Re: City of Palmdale Hybrid Power Plant Project: Docket No. 08-AFC-9

PALMDALE HYBRID POWER PROJECT (08-AFC-09)
CEC STAFF INFORMAL CULTURAL DATA REQUESTS 1 – 3

Technical Area: Cultural Resources

POLE #69

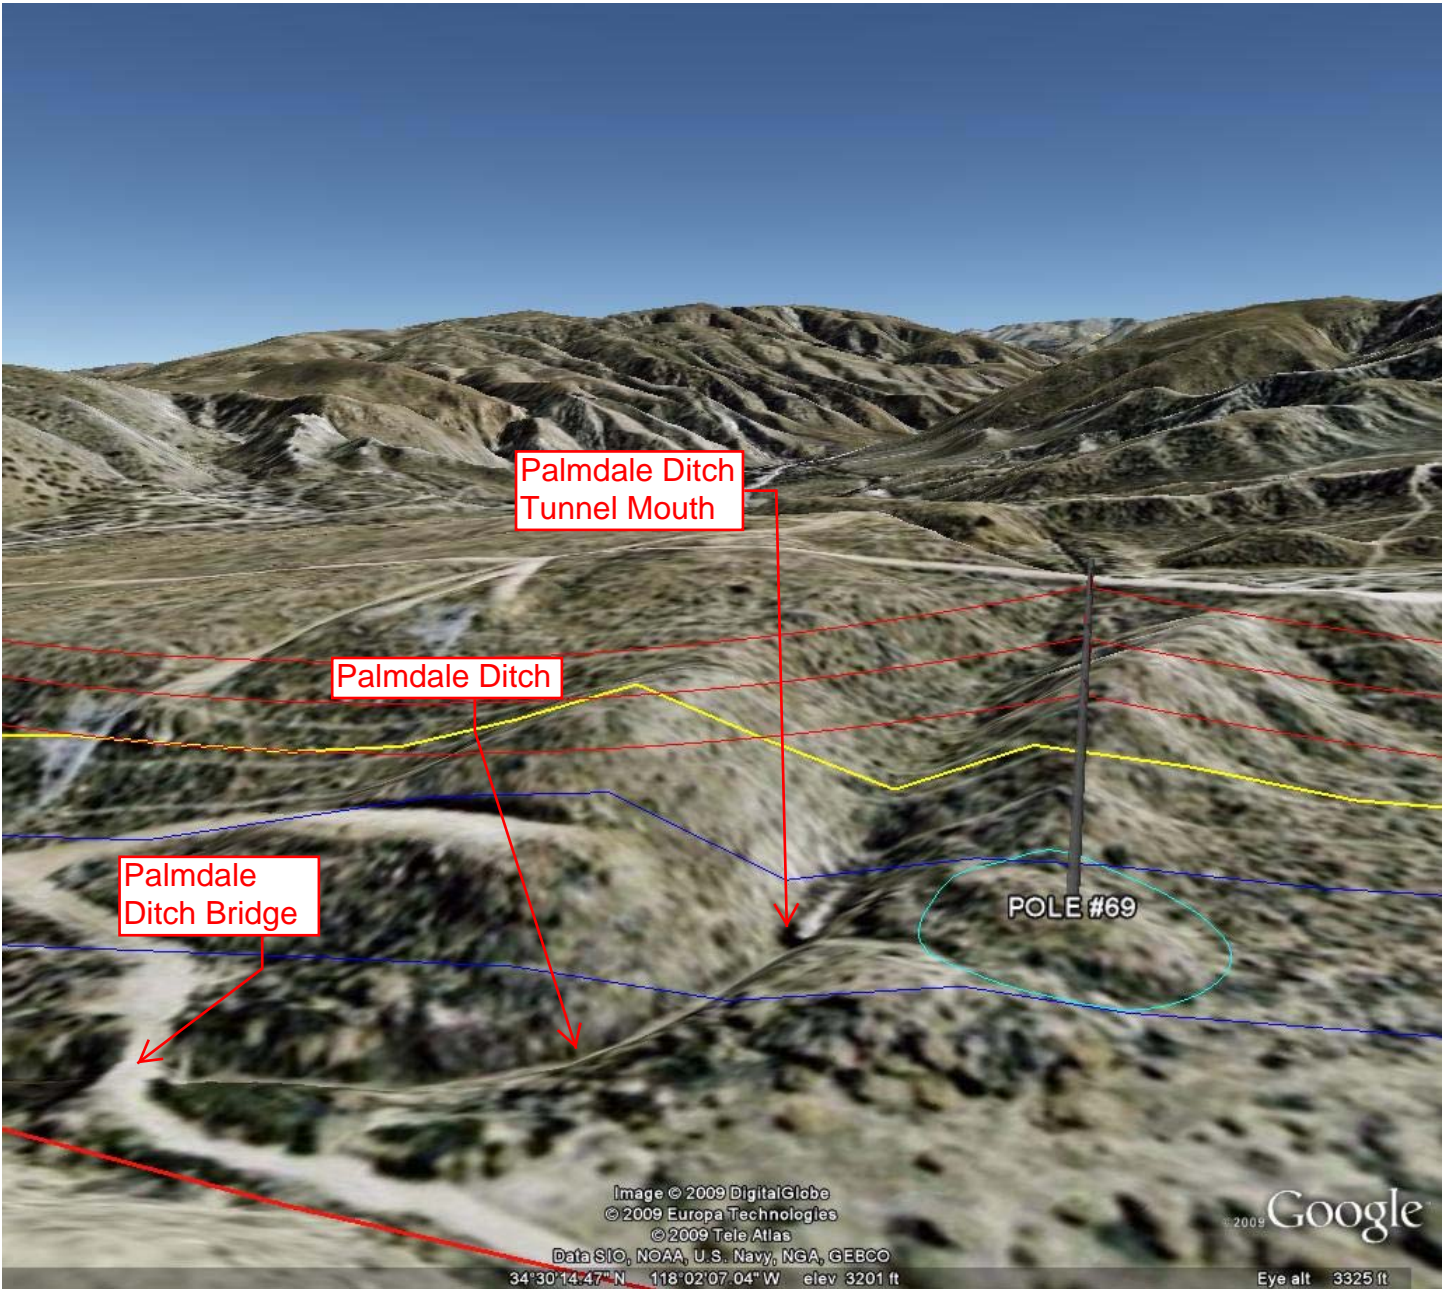
Please provide a description of the poles (type, height, number of poles or foundations needed for each) that would be installed in this location. Please determine how close the replacement pole(s) are to the Palmdale ditch tunnel, show the horizontal relationship in a detailed plan drawing, and show the vertical relationship in a detailed section drawing. Please provide the size, the number, and the depth of the holes needed for installation of the poles. Please explain how the project would avoid impacts to the Palmdale Ditch from pole installation in this location.

The entrance to the Palmdale ditch tunnel is located approximately 450 feet southwest of the proposed location of pole 68 and approximately 90 feet east of the proposed location for pole 69 of Segment 2. The area of disturbance for pole installation is proposed to be a 50 foot radius around the pole. No construction activities will take place outside the indicated disturbance area. That being the case, there will be an additional 40 feet from the outside edge of the disturbance area to the mouth of the Palmdale ditch tunnel. In addition, Applicant will take all required precautions and implement BMPs to mitigate erosion from the installation site from potentially impacting the Palmdale ditch.

In summary, the proposed new poles and construction activities will not impact the Palmdale Ditch and related tunnel because all of the proposed construction activity will take place within the proposed area of disturbance, the outside edge of which is 40 feet from the mouth of the Palmdale Ditch tunnel.

Applicant has previously submitted a .kmz file identifying the proposed pole locations and areas of disturbance for the entire transmission linear route. Attached are two static images from the same

file that provide a horizontal and vertical view of the proposed pole location in relation to the Palmdale Ditch and tunnel. These images will show that construction of the proposed pole at this location will avoid a significant impact on the Palmdale Ditch and tunnel.
